Client/Project
IMMUCELL

Title
SECOND FLOOR - CONDENSATE PIPING PLAN

Scale 1/4" = 1'-0"
Drawing No. **MP-402-C**

1 SECOND FLOOR - CONDENSATE PIPING PLAN
MP-402-C 1/4" = 1'-0"

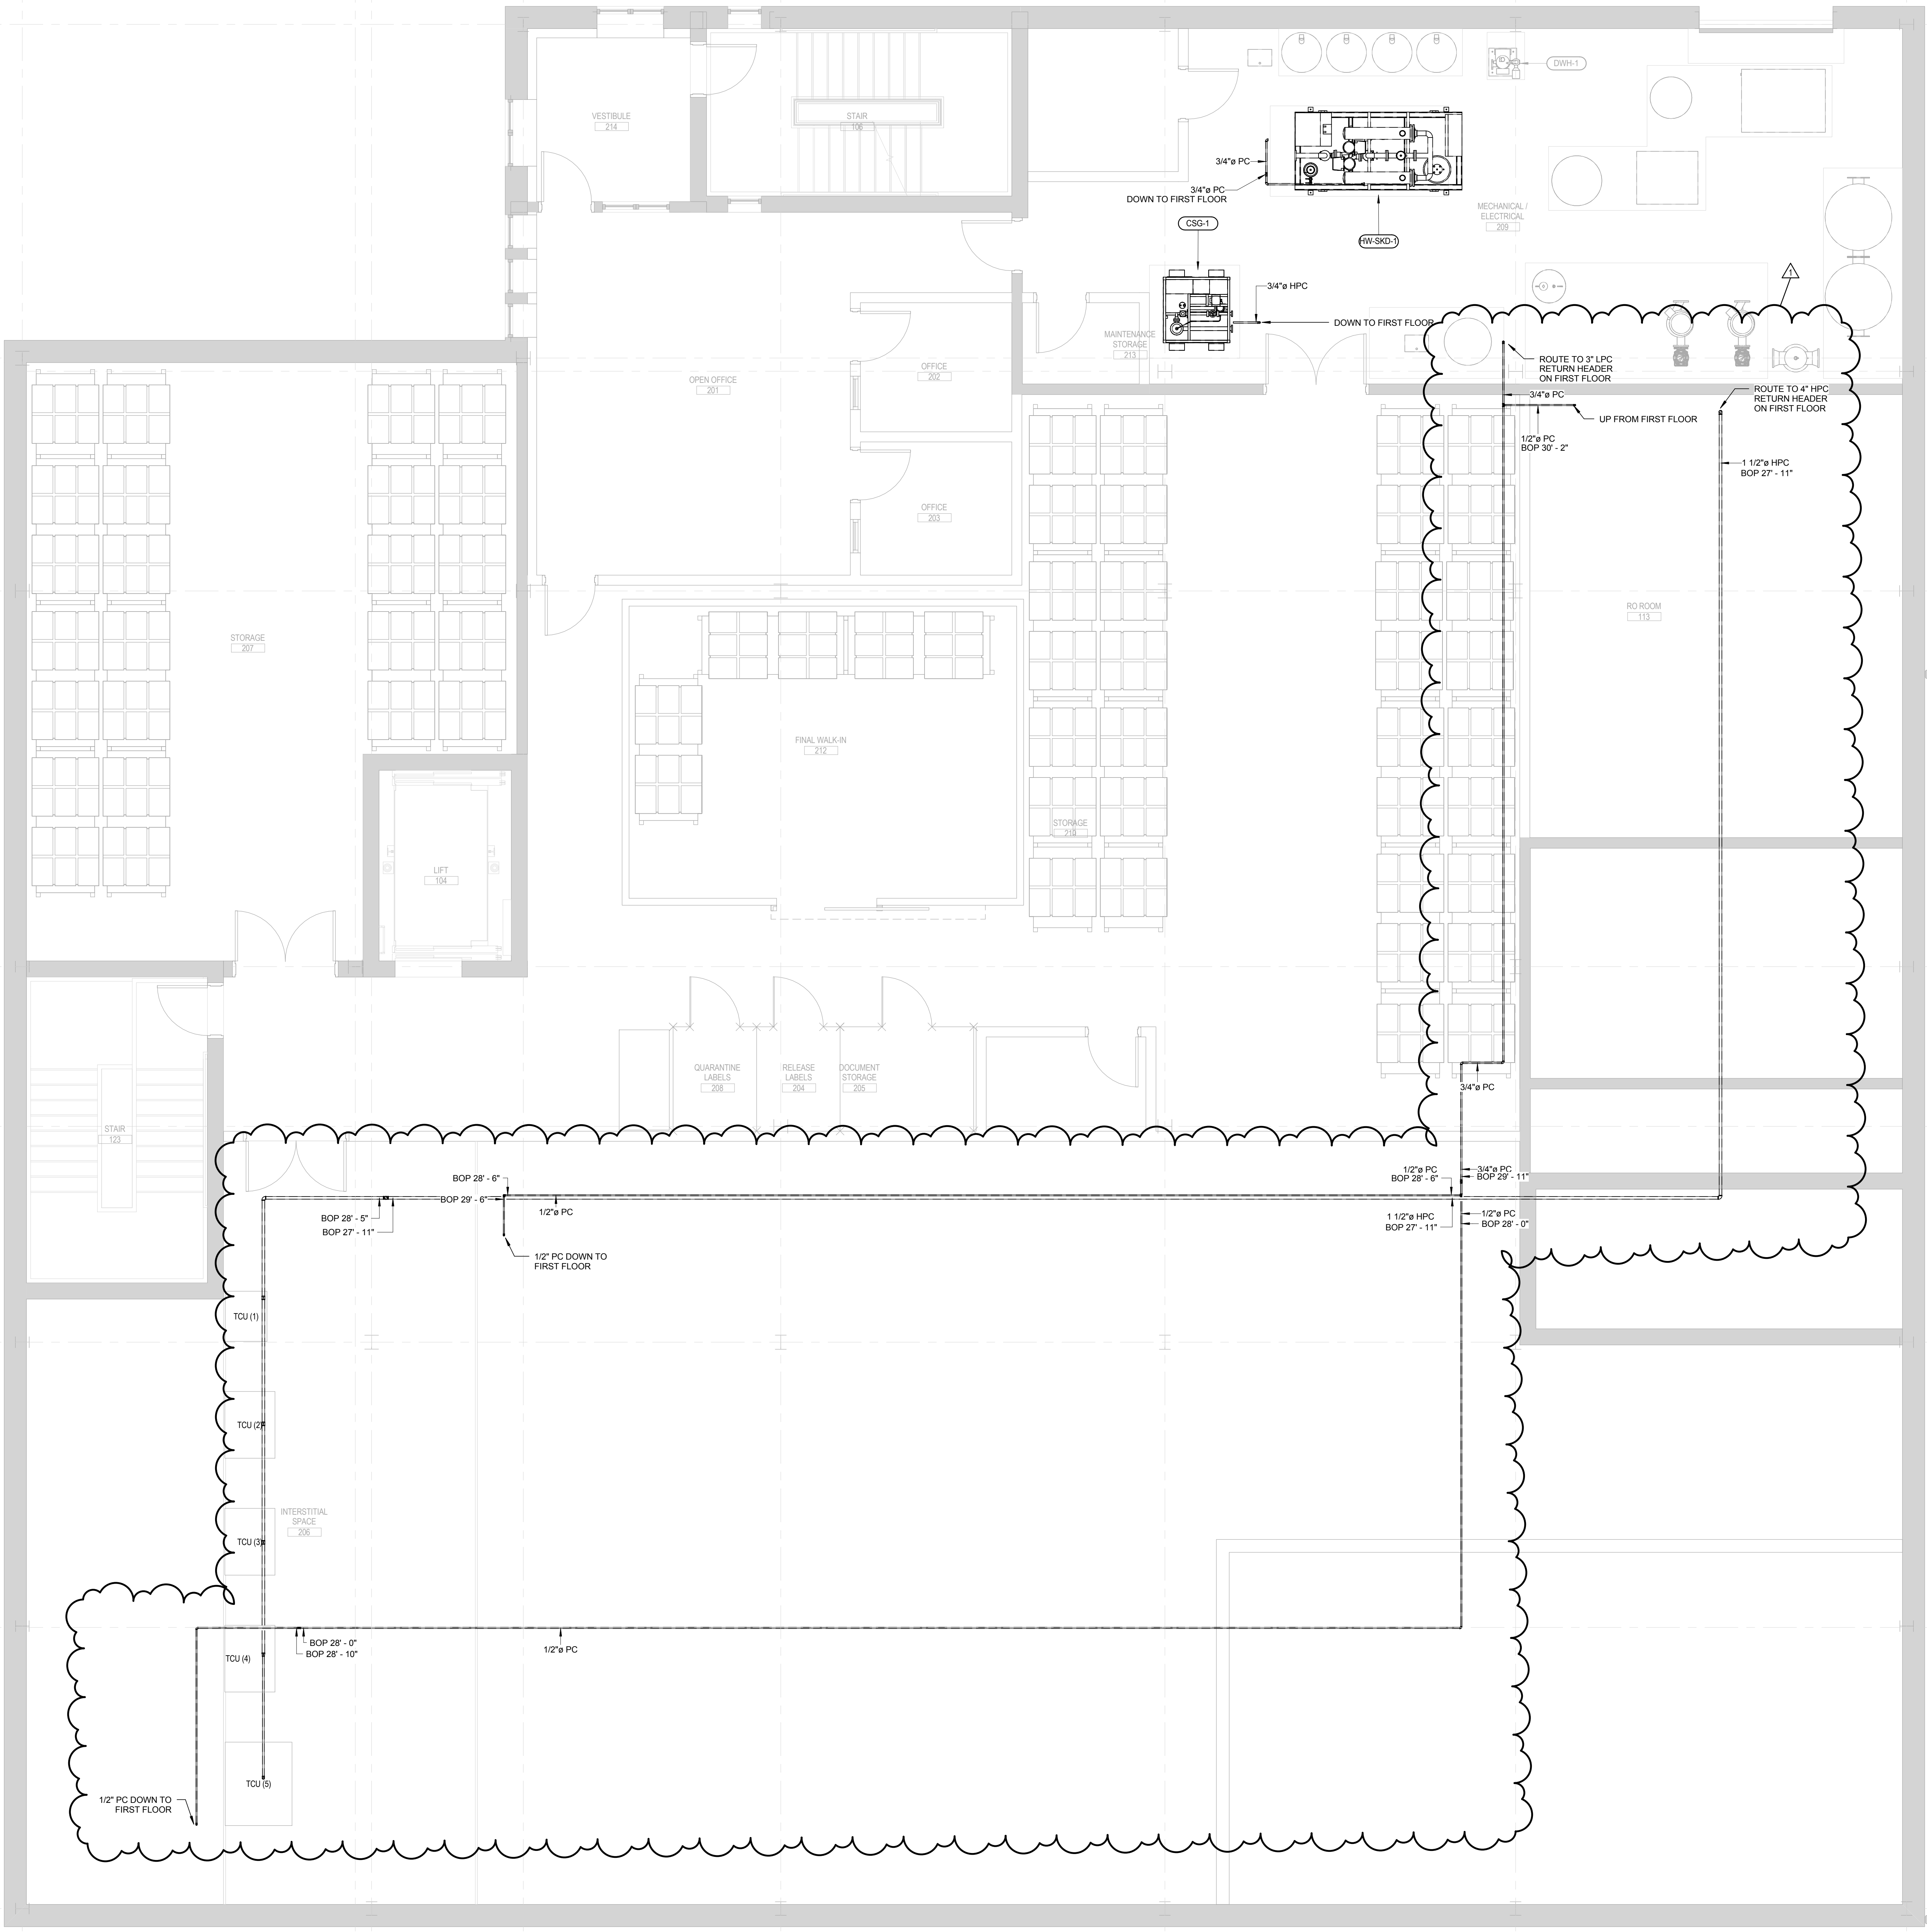
REVISED NOTES

- PROVIDE CARBON MONOXIDE DETECTOR WHERE INDICATED.
